PRELIMINARY PLAT AMENDMENT

STAFF REPORT

VENETIAN GOLF & RIVER CLUB

PHASE 5-PALERMO

2019 Proposed Landscape Plan

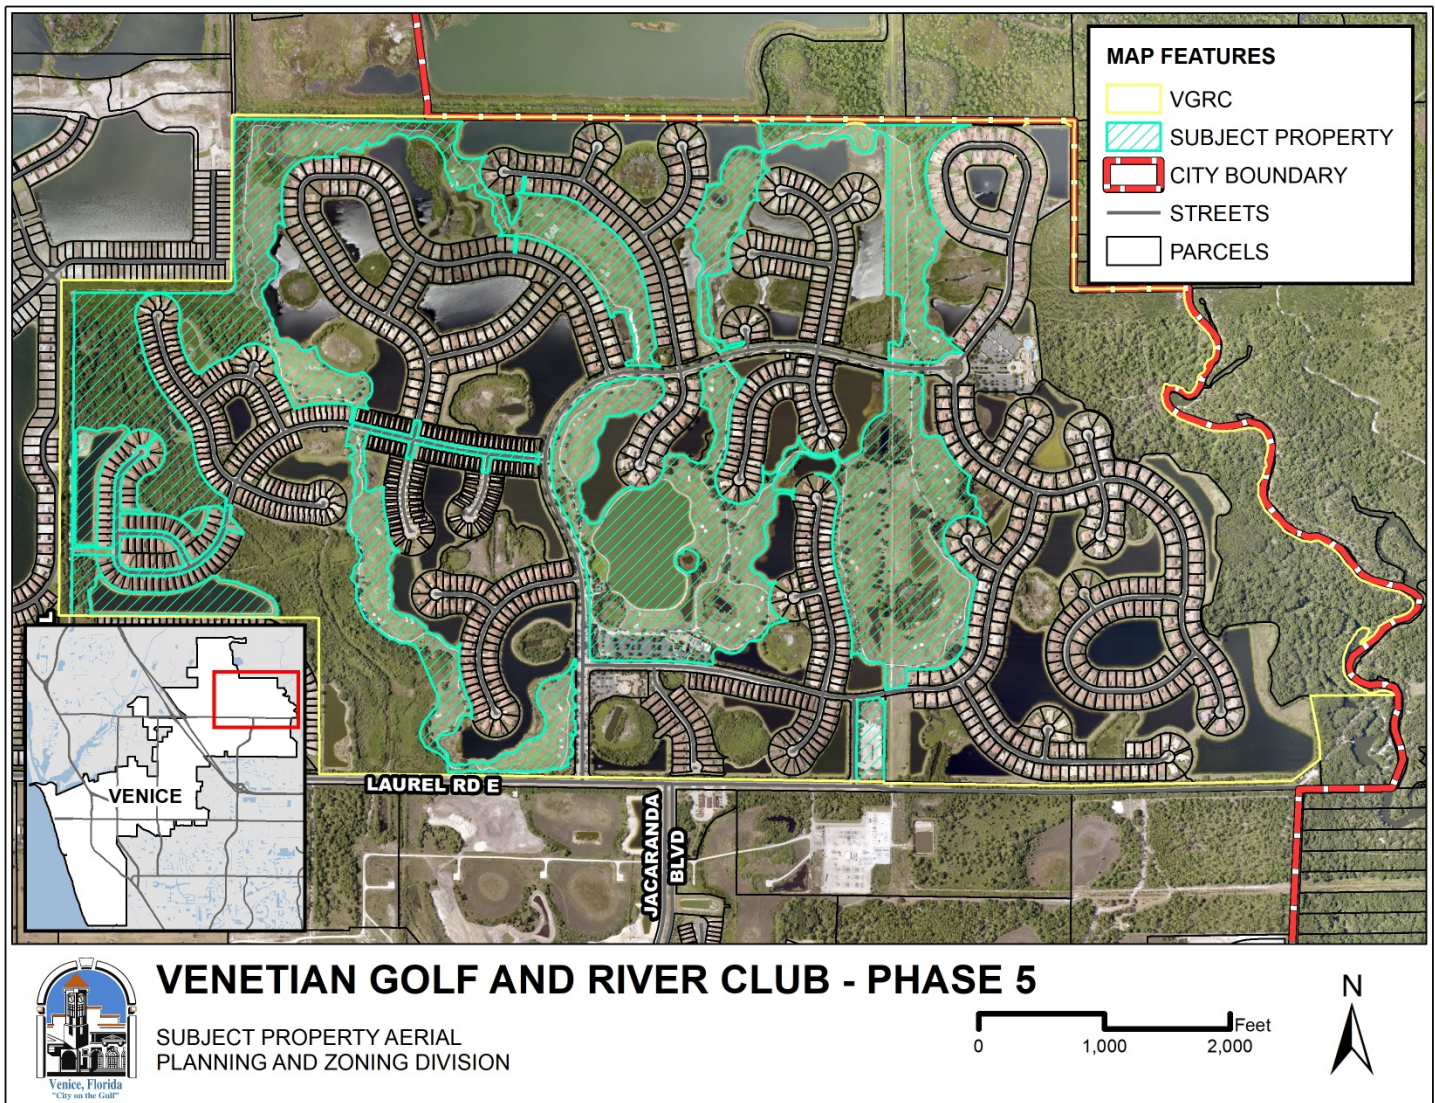
Based on the above indications, the applicant has submitted the proposed amended landscape plan along with the previously approved plan and an aerial depicting locations along the golf course where an additional 228 trees will be planted. These trees will be planted in locations that will fill in gaps in perimeter buffers and will not be planted in locations that would hinder any residents existing views. The applicant has indicated that the proposed plan includes one tree per lot which exist, for the most part, today as street trees. There is also flexibility in the proposed plan regarding species, as the strictly required live oaks in the previous plan have caused problems with underground infrastructure. Multiple tree species are now indicated as acceptable for front yard planting.

Finally, to confirm compliance and memorialize the proposed changes to the originally approved landscape plan, the applicant has proposed a modified landscape plan for consideration by the City. The plan has been reviewed by both City staff and County staff and no compliance issues have been identified. The newly proposed landscape plan will memorialize existing landscaping along with the proposed modifications and will provide opportunity for the Palermo neighborhood of the VG&RC community to gain compliance with an approved plan.

The “Proposed Planting List” provided in the revised landscape plan is consistent with these requirements. It is important to note that much of the material onsite will remain unchanged and will be confirmed compliant through this process. Therefore, the subject petition may be found consistent with the City’s LDC.
